Independent Technical Audit of Los Alamos National Laboratory for Compliance with the Clean Air Act, 40 CFR 61, Subpart H in 2001

DOJ File Number: 90-5-1749A

Case Name: *CCNS v DOE*

October 2002

Figure 1 November 2001 gamma dose rate at the NEWNET East Gate (new) station
Note: the 41 µR/hr value on 11/28 was considered to be erroneous

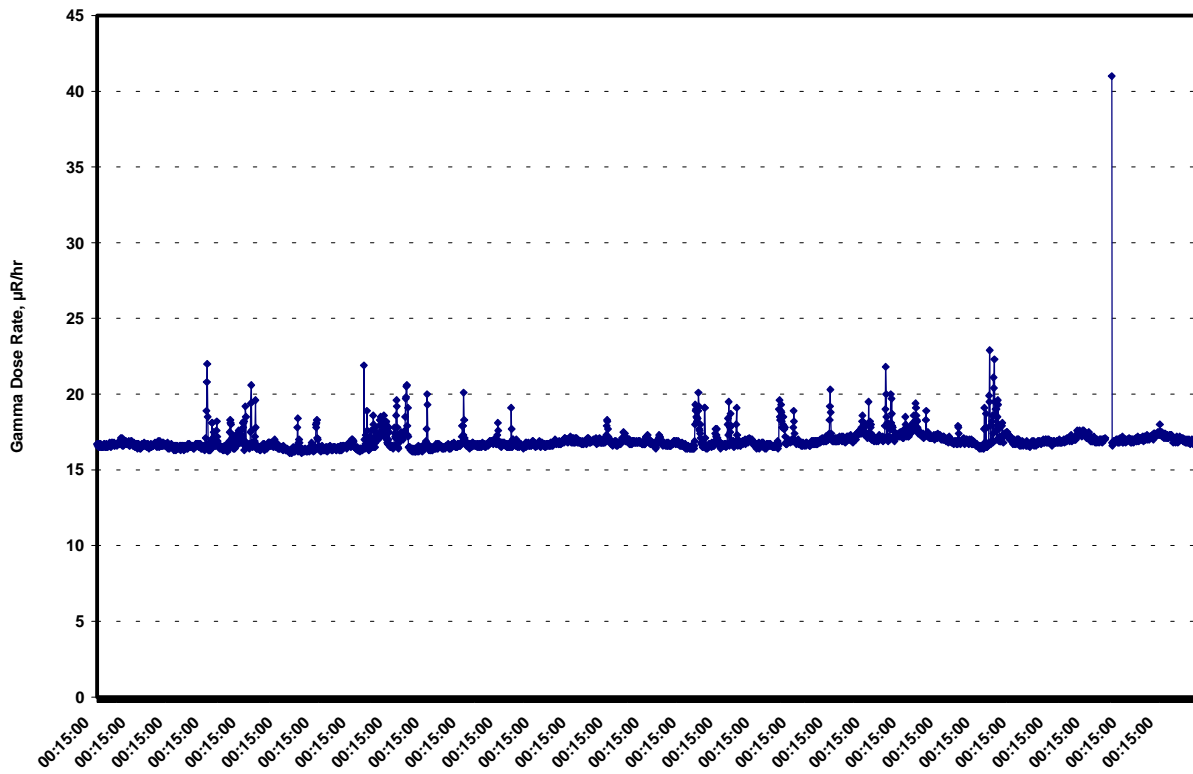
I present a somewhat different approach for the month of November 2001. Upon inspection of the gamma dose rate over time (Figure 1), a gradual shift is evident which may likely be due to instrument calibration.

Figure 4 December 2001 gamma dose rate at the NEWNET East Gate (new) station as a function of wind direction in degrees

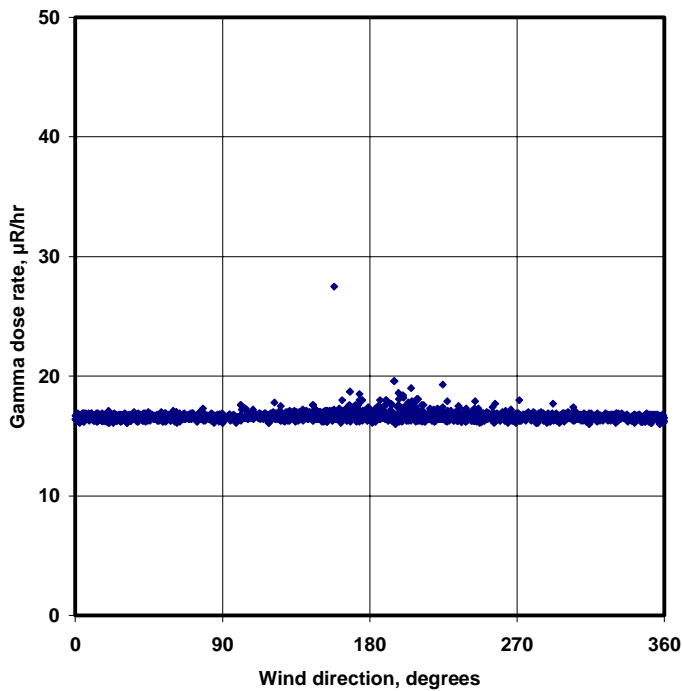
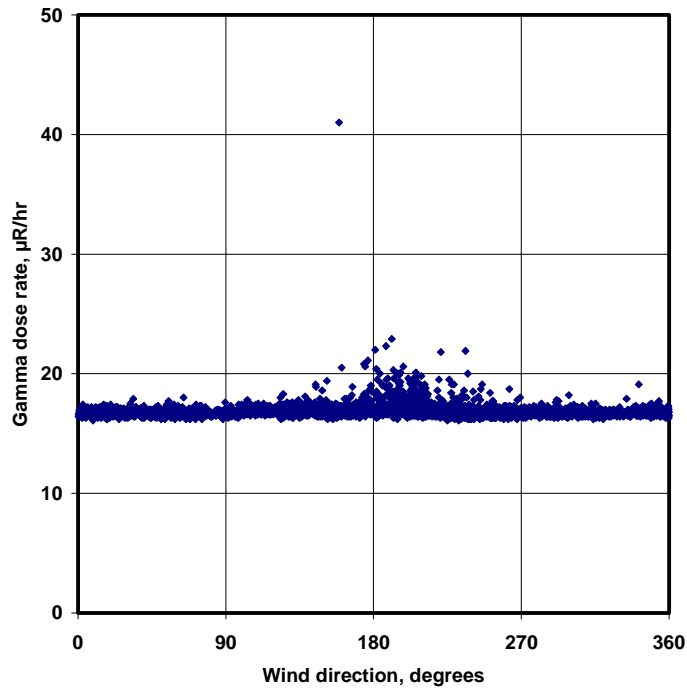
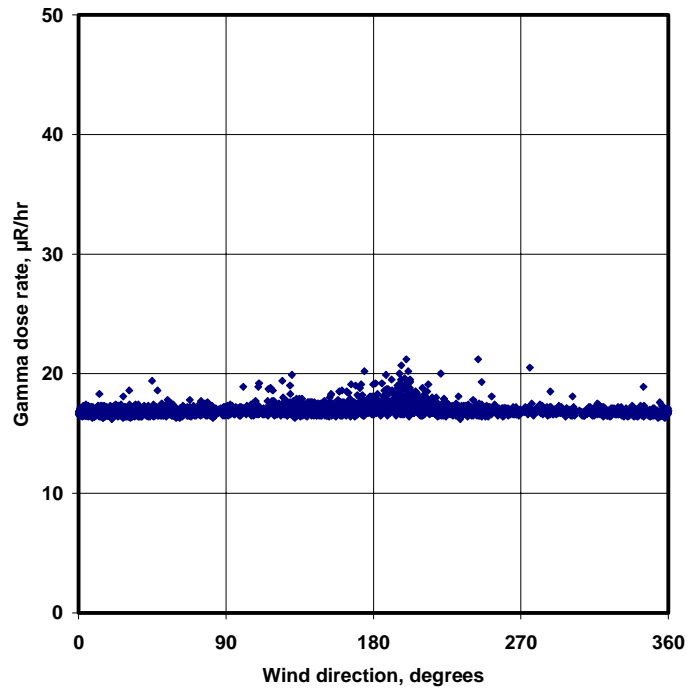
In addition, I would like to direct attention to the gamma dose rates as a function of the wind direction in the month December 2001 (Figure 4) compared to the data for October 2001 (Figure 2) and November 2001 (Figure 3). The increases in gamma dose rates at wind directions <90 and >270 degrees in the month of December 2001 are difficult to explain and may indicate electronic

noise at this station. That comes as a surprise because the station East Gate (new) was equipped with new data loggers that are supposed to have rectified the noise issue.

Figure 1 Wind speed as a function of wind direction at East Gate NEWNET station, August 2002

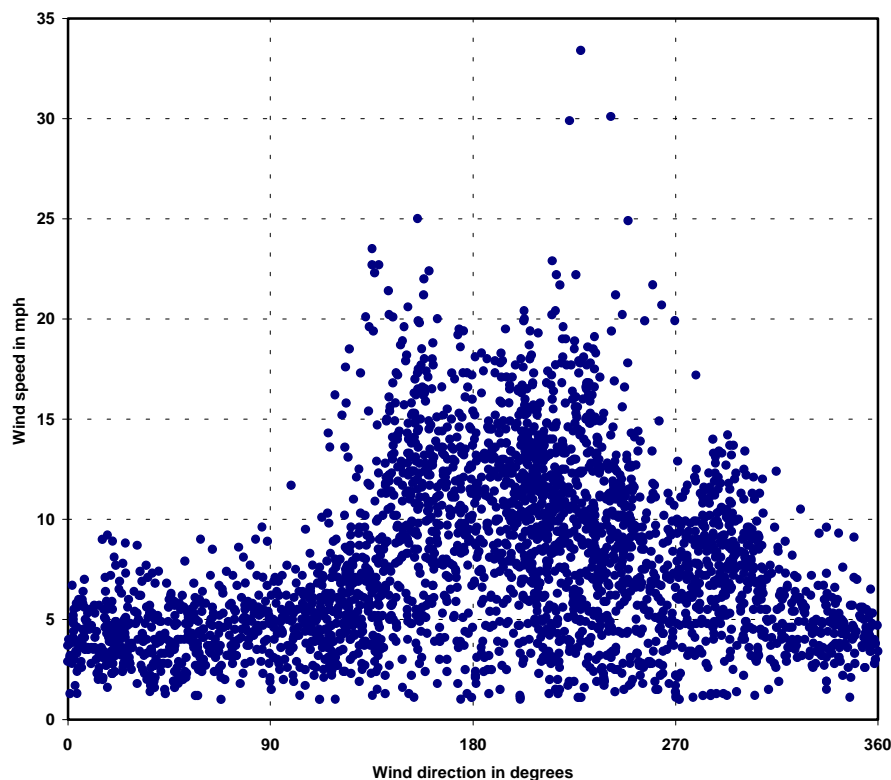
The underlying calculation assumes a steady-state release and is modelled with a simplified flat-terrain model. Both assumptions are not valid in this case. The use of a complex terrain model may lead to a different conclusion for a "TA-21 East" source. In addition, the releases from a diffuse source are most likely to occur during high wind speeds (>10 mph) when material can be readily suspended into air. High wind speed situations are more likely during wind blowing from the South/Southeast (see Figure 1).

With regard to diffuse sources at TA-21-East, the wind speed/direction pattern suggests that the greatest impact to residents from such a source is likely at the North Mesa residences.

Figure 1. Gamma dose rates in August 2002 at NEWNET stations Los Alamos High School, Espanola, and Ohkay Owingeh

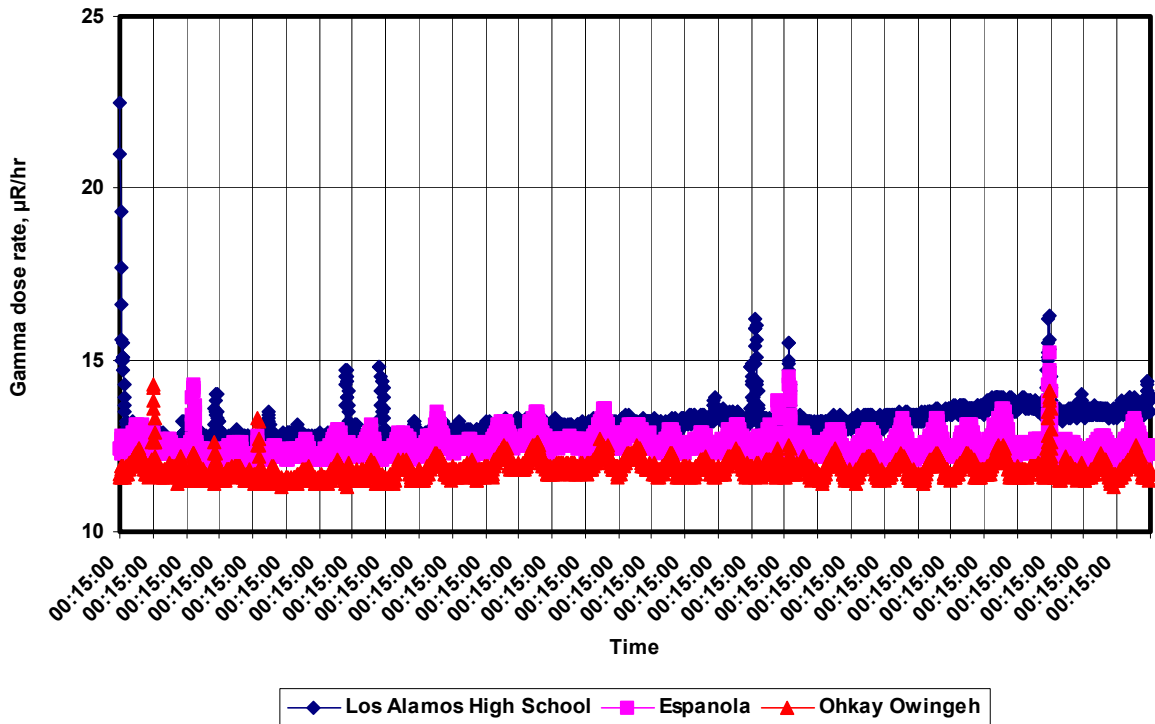
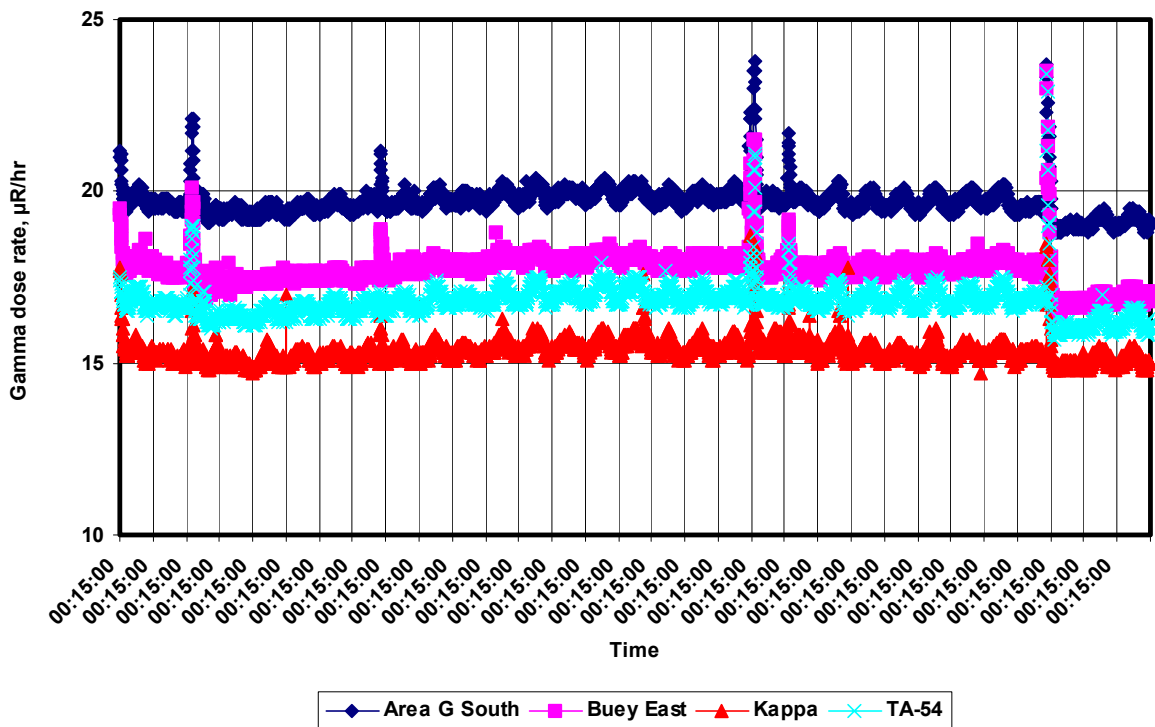
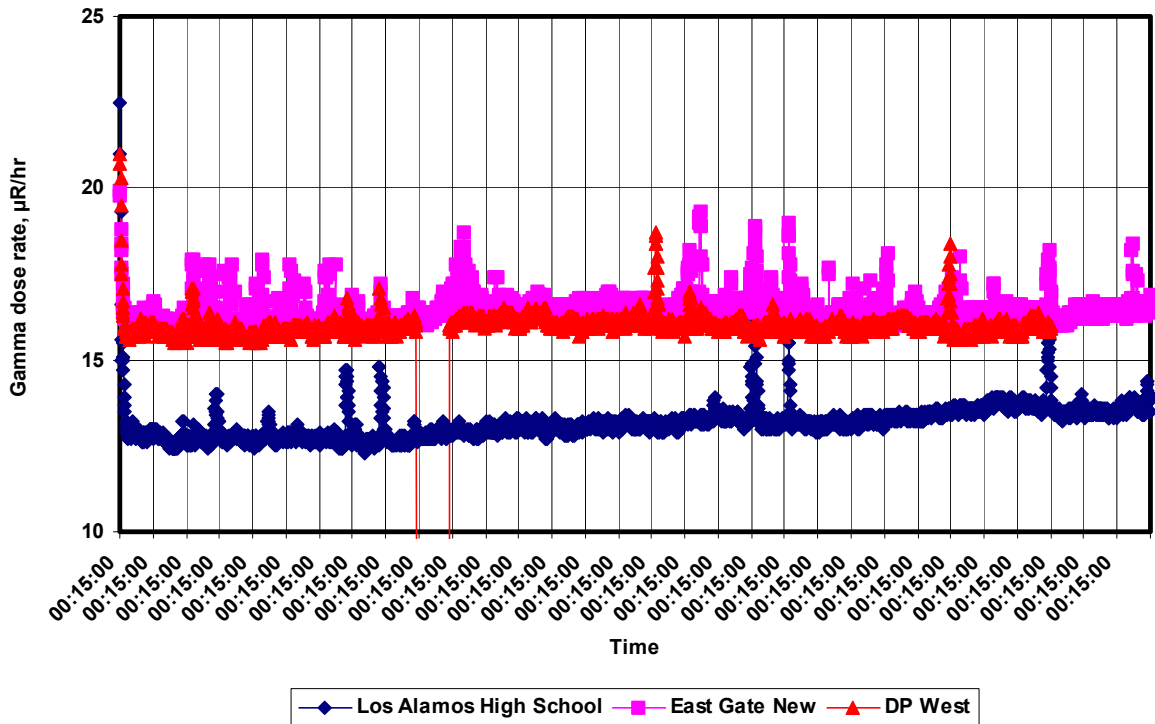
A better analysis is possible by plotting the data for selected close-by stations over time (Figures 1 to 3). An overview map indicating the location of LANL stations is given in Figure 4. The daily cycle in gamma dose rate is clearly visible. It is, however, missing for the "Los Alamos High School" station. Gamma dose rates increased significantly simultaneously which appears to be due to weather events. In this respect it is noteworthy that the station
